Service Bulletin

Bulletin No.: 21-NA-071

Subject: DTC's P05AE or P059F Set Current or History

Brand:	Model:	Model Year:		VIN:		Engine:	Transmission:
		from	to	from	to		
Chevrolet	Silverado 2500HD/3500HD	2020	2021			All	All
GMC	Sierra 2500HD/3500HD

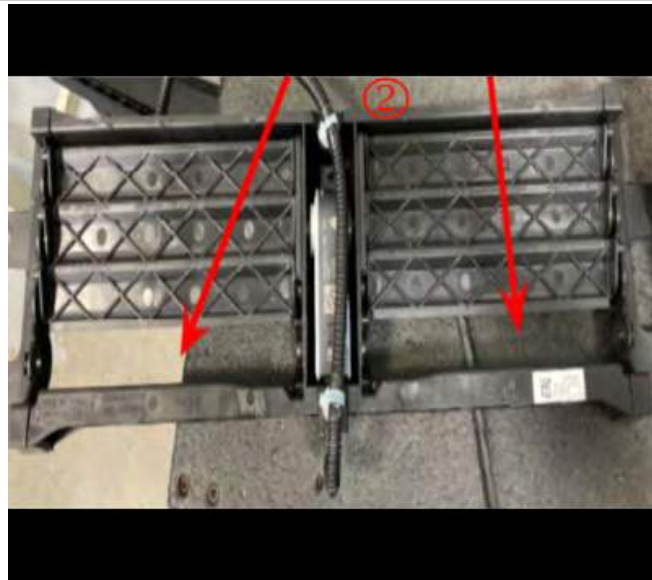
Involved Region or Country	North America, Saudi Arabia, Israel, Chile
Additional Options (RPOs)	
Condition	Customers may come in for service and technician may find either of the DTC's listed below set in current, or history. " DTC P05AE - Active Grille Air Shutter 2 Performance " DTC P059F- Active Grille Air Shutter 1 Performance
Cause	The cause of the condition may be road debris like small stones, or ice, may collect at the bottom of the front bumper lower shutter assembly and can prevent the louver from fully closing, causing the DTC's to set.
Correction

Note: The graphics above show before (1), and after (2), examples of the lower shutter modification.

Remove the front bumper lower shutter and complete the Lower Shutter Louver Modification Procedure below, to remove the lowest row of louvers from the shutter.

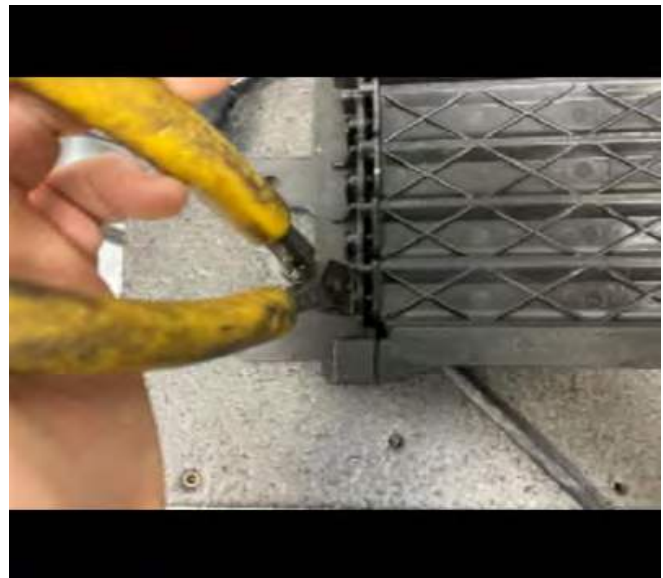
Tip: Pushing the lower louver outboard will allow you to cut more of the pin, which will aid in the louver removal later in the procedure.

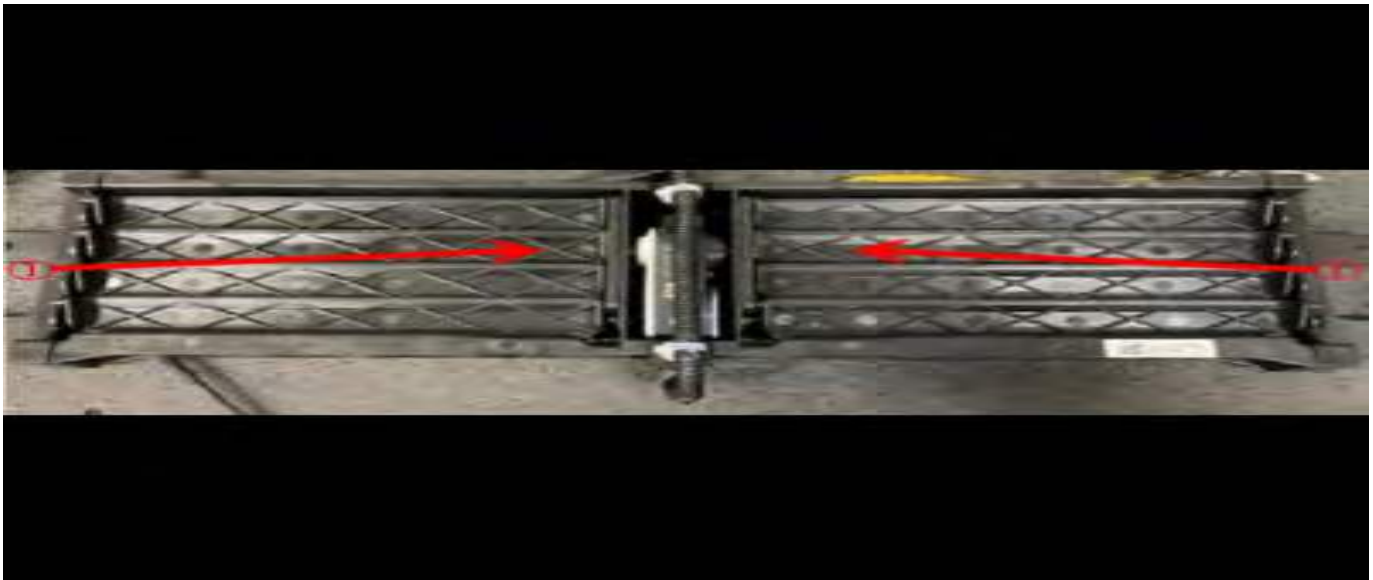
2. Using side cutters, snip the outer pivot pins of the 2 lower louvers.

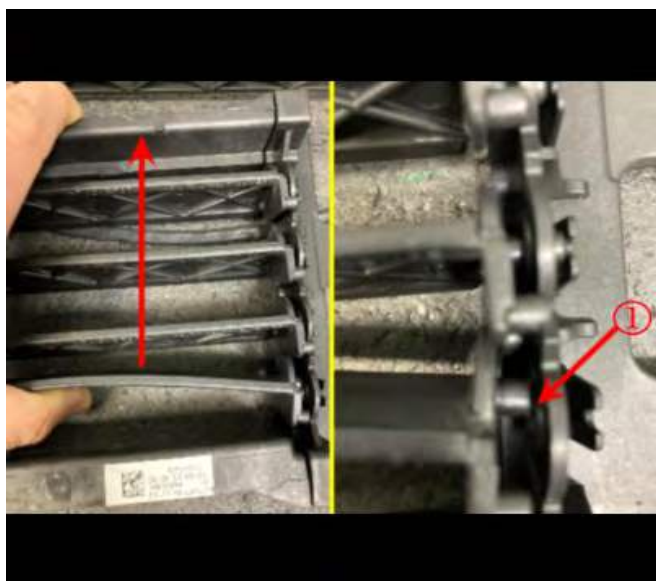
Tip: This cut is easier to accomplish with the shutter standing on end.

5. Using the rotary tool, cut the link bar (2) of the lowest louver (3), just below the louver link pin (1) above the lowest row.
6. Remove the lower louver following the steps below.

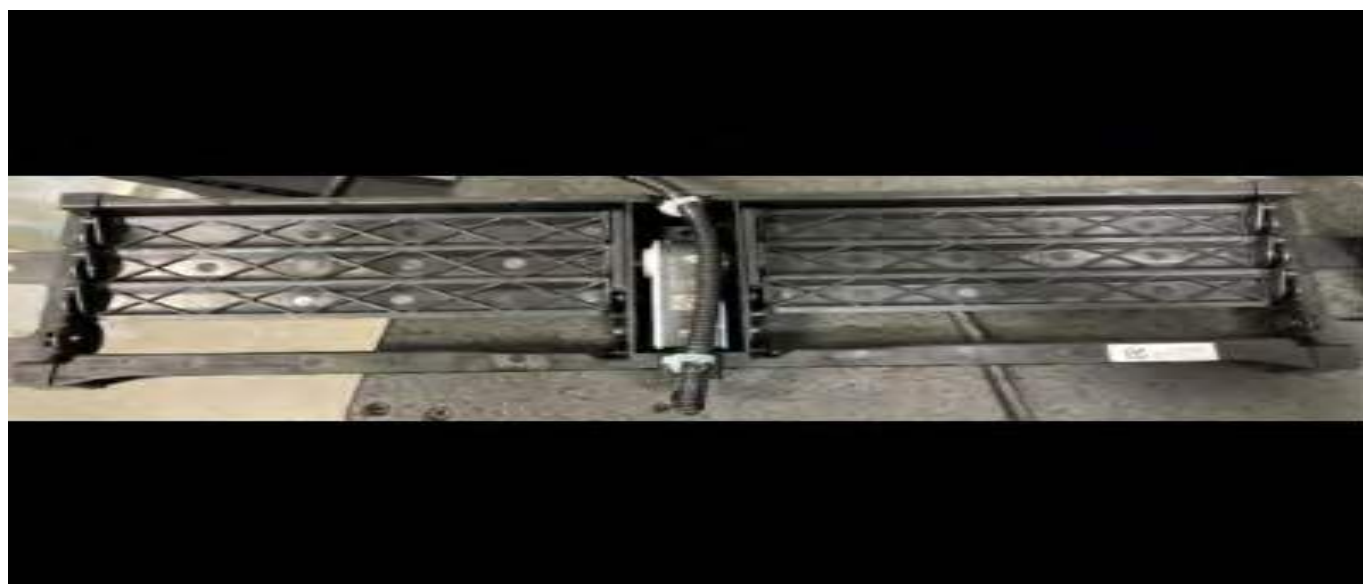
- 6.1. Bend the louver upwards until the previously cut outboard pivot pin (1) ejects out of the hole.
- 6.2. Then remove the louver and the cut link section.
